Contract #: 04-0120F4Cty: SF/ALA Rte: 80 PM: 13.2/13.9File #: 69.28**WELDING INSPECTION REPORT****Resident Engineer:**Pursell, Gary**Address:** 333 Burma Road**City:** Oakland, CA 94607**Report No:** WIR-015162**Date Inspected:** 21-Jun-2010**Project Name:** SAS Superstructure**OSM Arrival Time:** 700**Prime Contractor:** American Bridge/Fluor Enterprises, a JV**OSM Departure Time:** 1900**Contractor:** Zhenhua Port Machinery Company, Ltd (ZPMC), Changxing Island **Location:** Shanghai, China**CWI Name:** Mr. Chen Xi**CWI Present:** Yes No**Inspected CWI report:** Yes No N/A**Rod Oven in Use:** Yes No N/A**Electrode to specification:** Yes No N/A**Weld Procedures Followed:** Yes No N/A**Qualified Welders:** Yes No N/A**Verified Joint Fit-up:** Yes No N/A**Approved Drawings:** Yes No N/A**Approved WPS:** Yes No N/A**Delayed / Cancelled:** Yes No N/A**Bridge No:** 34-0006**Component:** Orthotropic Box Girder(OBG)**Summary of Items Observed:**

WELDING INSPECTION REPORT

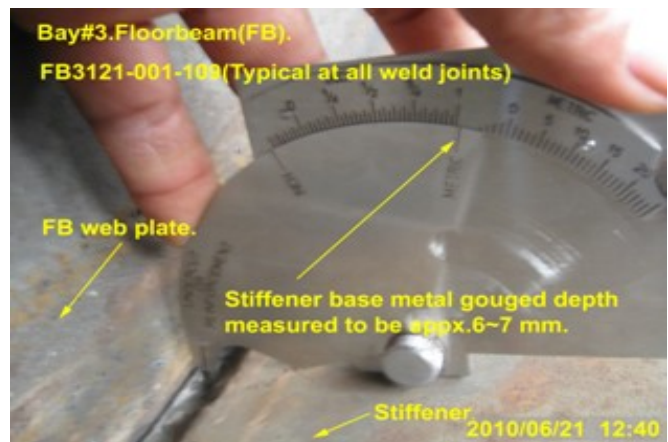
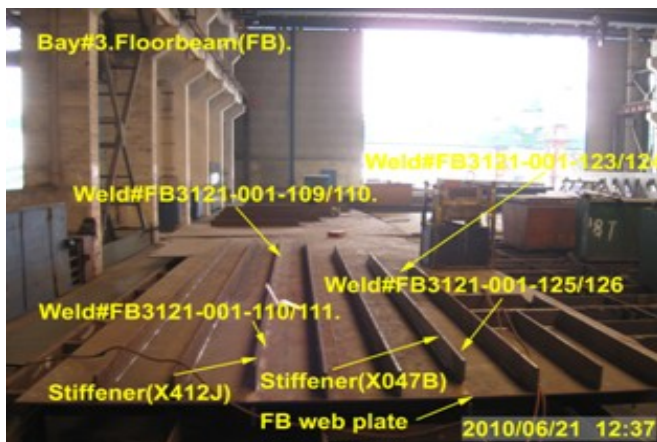
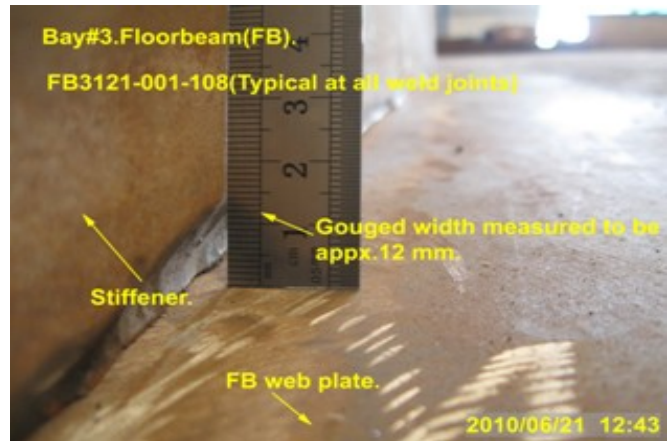
During the Quality Assurance (QA) random in process observations of the fabrication of Orthotropic Box Girder (OBG) Floor beam FB3121A, this QA Inspector observed ZPMC removed Seismic Performance Critical Material (SPCM) welds without Engineers approval as required per American Weld Society (AWS) D1.5 2002 section 12.17.3. The weld joints are identified as FB3121-001-108, 109, 123 and 124. Additionally this QA Inspector observed ZPMC has refit the two stiffeners and commenced re-welding them to the web plates of this floor beam without properly preparing the weld joints. Base metal that was removed from the edges of the stiffeners during the gouging operation has not been repaired and cleaned prior to re-fitting and welding. This QA measured the depth of the gouged areas of the edges of the stiffeners to be approximately 6mm.

This QA Inspector generated an incident report on this date for the above issue, for further information see the incident report and the attached photos.
